Kindly please review the following schematic since I am planning to design a new board due to so much unsolved errors in pervious board.

15 Series Li-ion Cells management using BQ76940

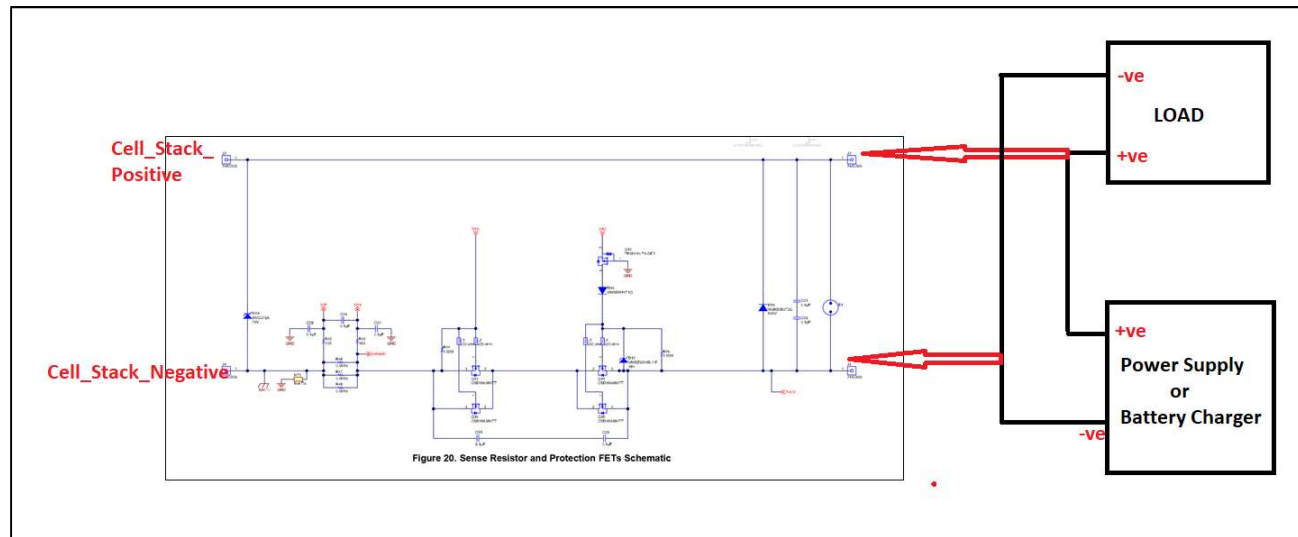
1. I designed circuit by referring “**TIDA-00449**” and “**TIDA-00792**”
2. Designing for Pack of 15 Cells.
3. Do we have to hold the host microcontroller till output of TPS3839 gives RST signal ? if not so , what is the purpose of uisng it?
4. The following schematics is mainly focused for proper working of BQ76940 , for rest of the interfacing with host controller , had no issue.

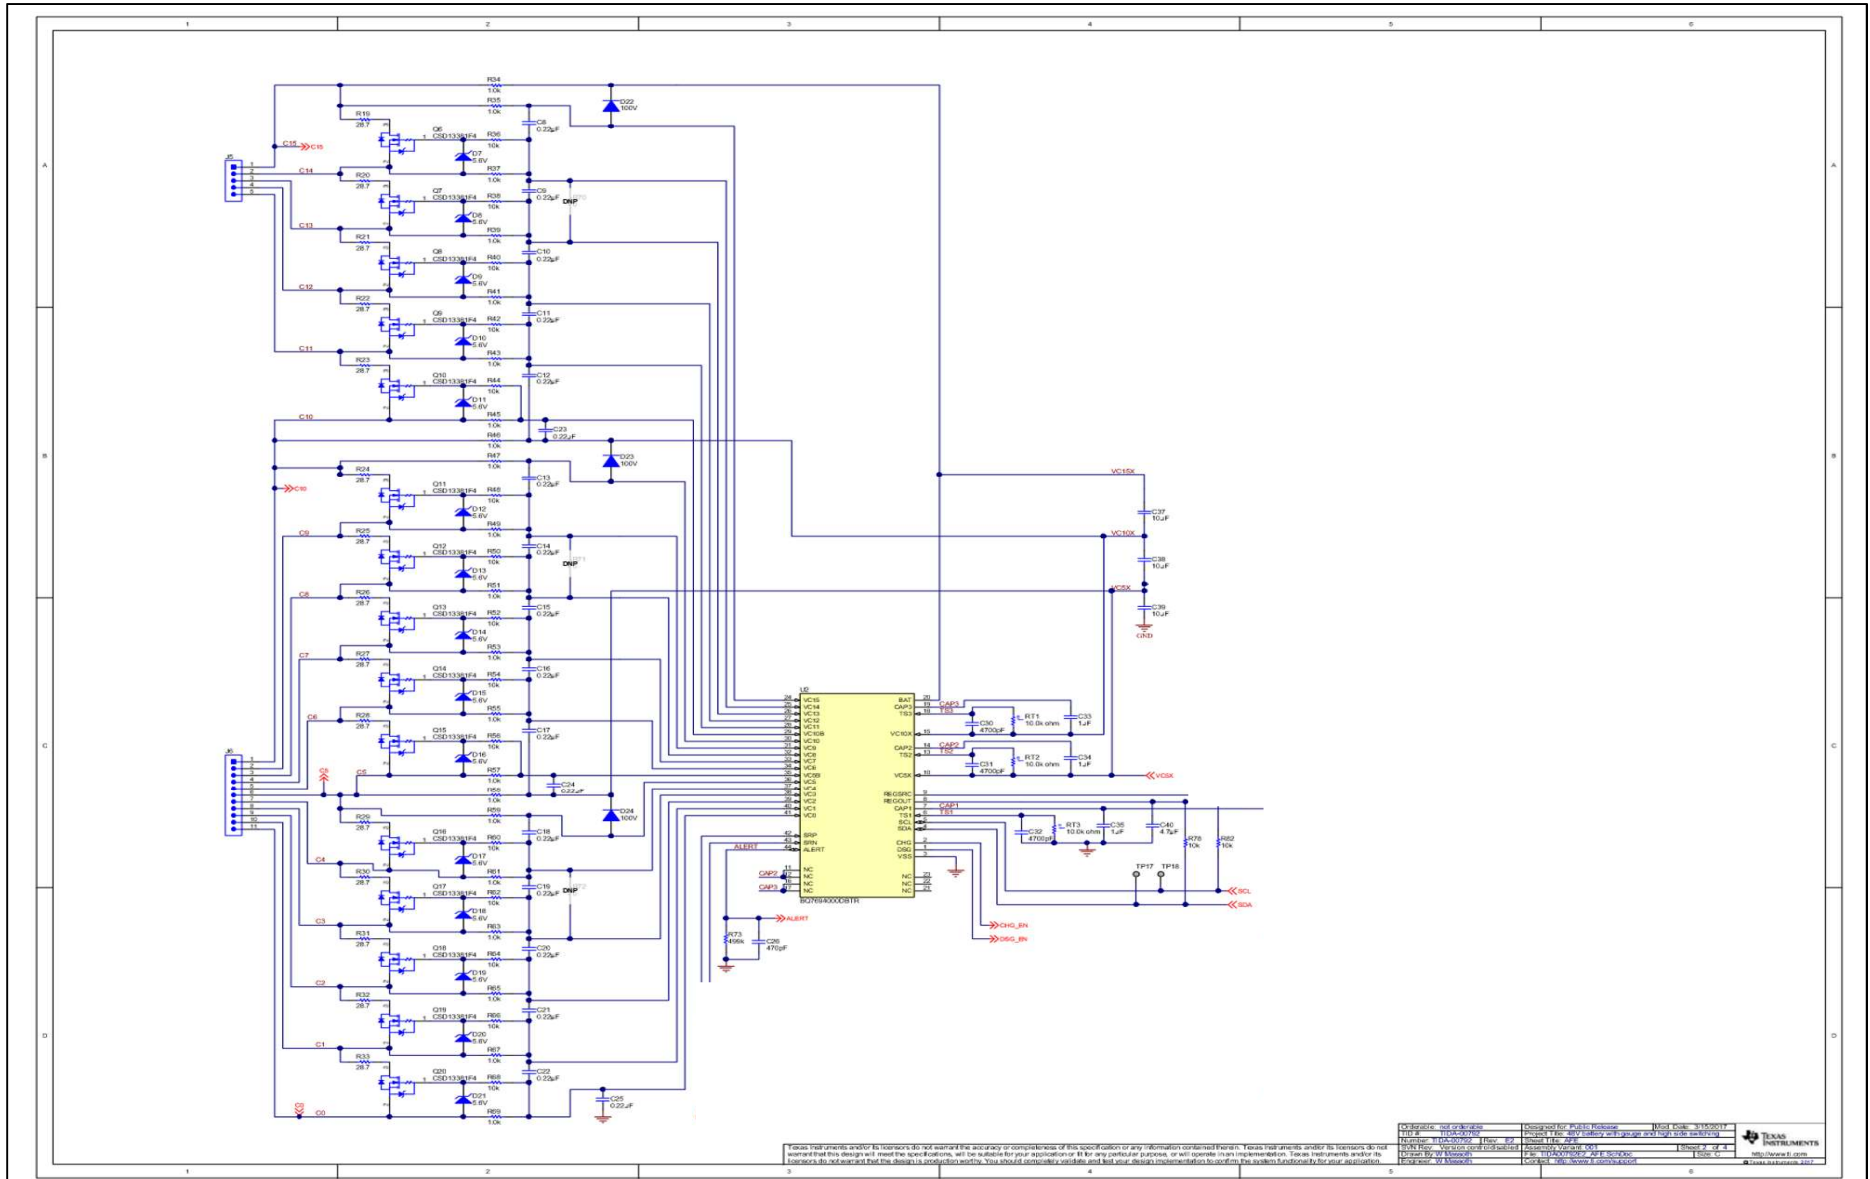
In both the reference designs , there are two negative terminals “BAT-” and “PACK-”.

So as per following block diagram , if I am not wrong I have to connect CELL_STACK_NEGATIVE_TERMINAL to “BAT-”

Power Supply and Load both connected to “PACK-” terminal

Load and Power Supply/Battery Charger is connected Parallely

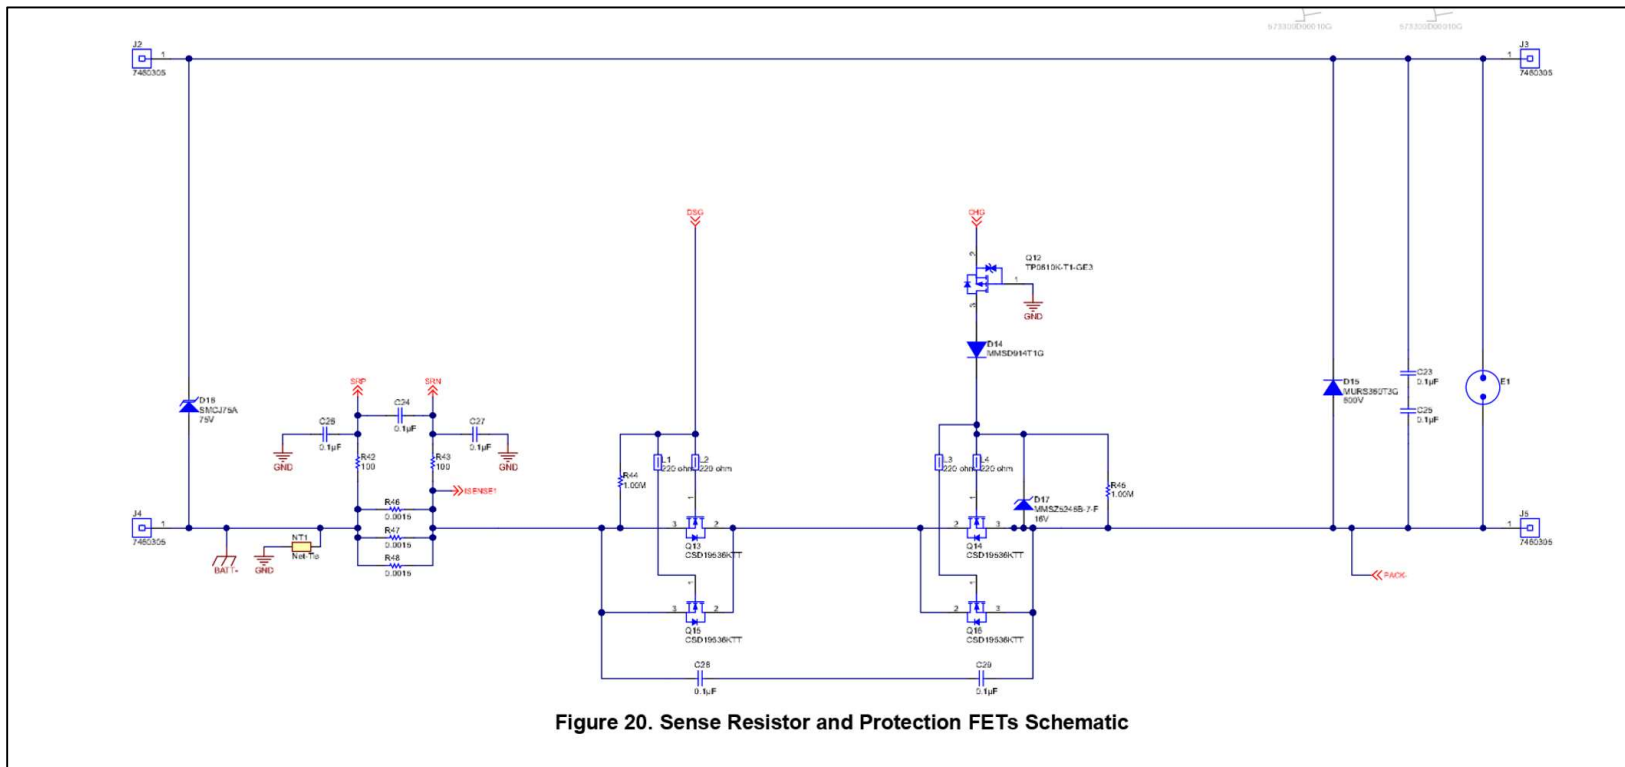
Is the following Circuit sufficient for Proper working of BQ76940.
